DOCKETED	
Docket Number:	22-BSTD-04
Project Title:	2022 Energy Code Photovoltaic and Battery Storage Cost Effectiveness Determinations
TN #:	254575
Document Title:	Staff Review and Analysis of Benjamin Apartments Project Application for a Solar Photovoltaic Cost-Effectiveness Determination
Description:	On June 7, 2023, C Note Limited Partnership (C Note LP), property developer, submitted an application to the CEC requesting a determination regarding whether the solar photovoltaic (PV) system requirements should apply to the Benjamin Project, a 108-unit low-rise multifamily project located within the City of Lodi permitted under the 2019 Energy Code. Staff has performed a cost-effectiveness analysis based on 1) the public agency rules adopted by the City of Lodi, and 2) PV system costs estimated in bids from electrical and solar contractors to install the PV system designs that C Note LP developed to comply with City of Lodi PV and electrical system regulations. Based on that information, staff finds that the solar photovoltaic system requirements are not cost-effective for the newly constructed 108-unit low-rise multifamily of Benjamin Project within the City of Lodi. Staff recomme

Figure 1: The Benjamin Project Site Plan

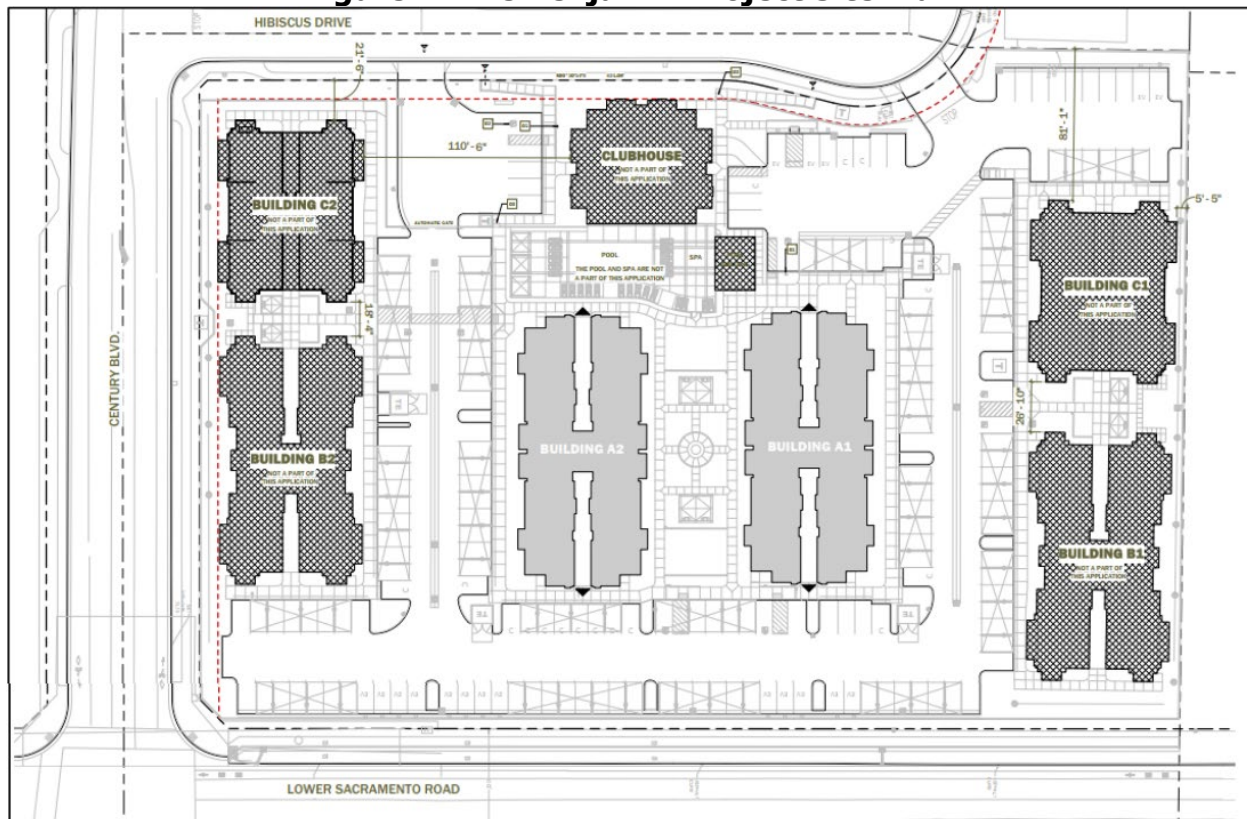
The Benjamin Project is an apartment complex with a total of six three-story apartment buildings including a clubhouse and pool building. The six apartment buildings are the subject of this application submitted to CEC on June 7, 2023. Figure 1 shows the site plan and Table 2 provides details about each building in the apartment complex. The apartment complex is served by the Lodi Electric Utility (LEU).

Figure 2: Floor Plan for Each of the Three Floors for Building C

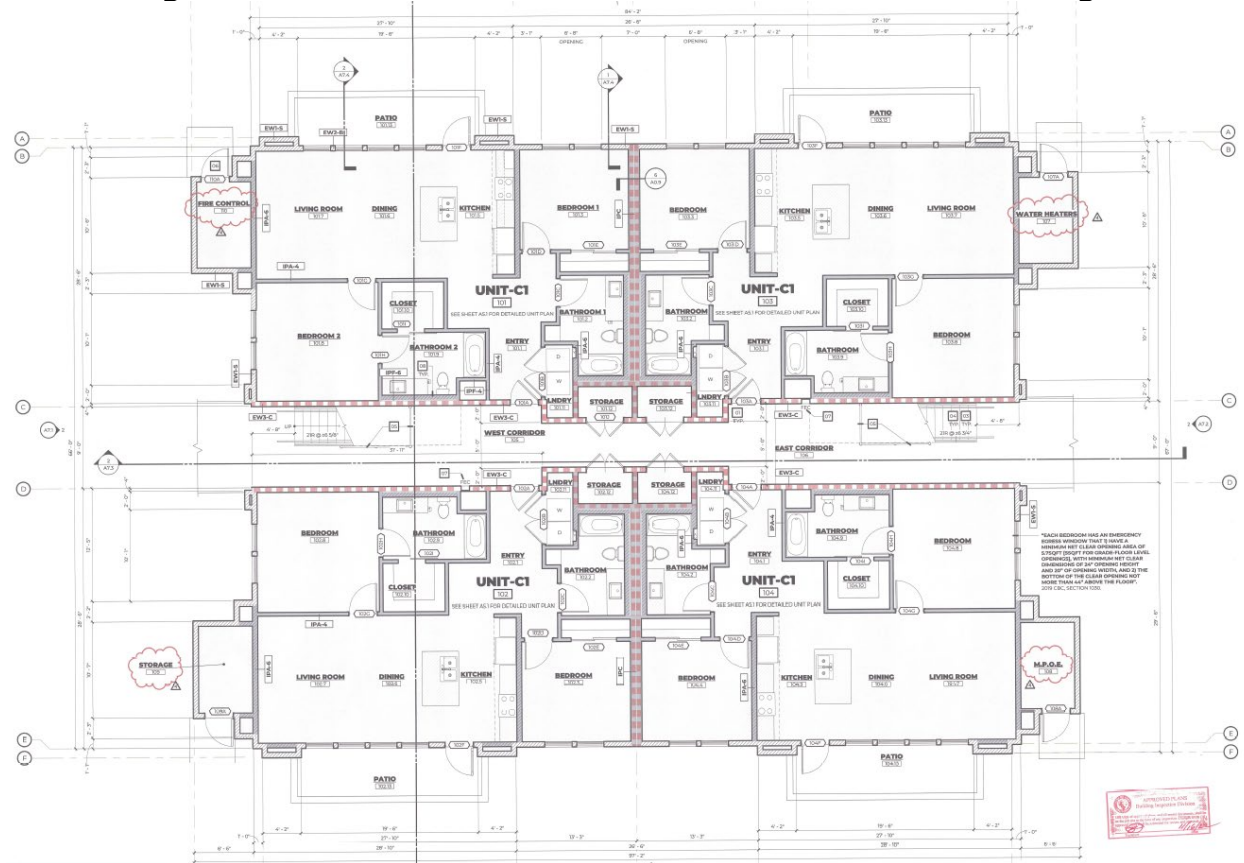
The cost-effectiveness of each apartment was evaluated separately because under the non-VNEM rules of the Lodi Electric Utility, each apartment unit receives its unique energy bill based on its energy consumption and the generation of its PV system. The consumption of the building as a whole is of no consequence to the energy bill of individual apartment units. Of the three apartment buildings in the Benjamin Project, Building C had the largest apartments, with each of the 12 apartments in the three-story building having a floor area of 1,202 ft². As seen in Table 3, the cost (\$/W) of the PV system was lowest for Building C, primarily because

the larger size of the apartments spread the costs of the PV system over a larger floor area. Staff concluded that if after performing²² the cost-effectiveness analysis, Building C was shown not to be cost-effective, then smaller apartment units in Buildings A and B would also not be cost-effective. This conclusion was tested by staff by modeling apartment units of various sizes and performing an LCC analysis using Lodi rates and the Chase & SED bid. Staff found that larger apartment units, under Lodi tariff, were more cost-effective than smaller units. Therefore, the analysis focused on Building C apartment units.
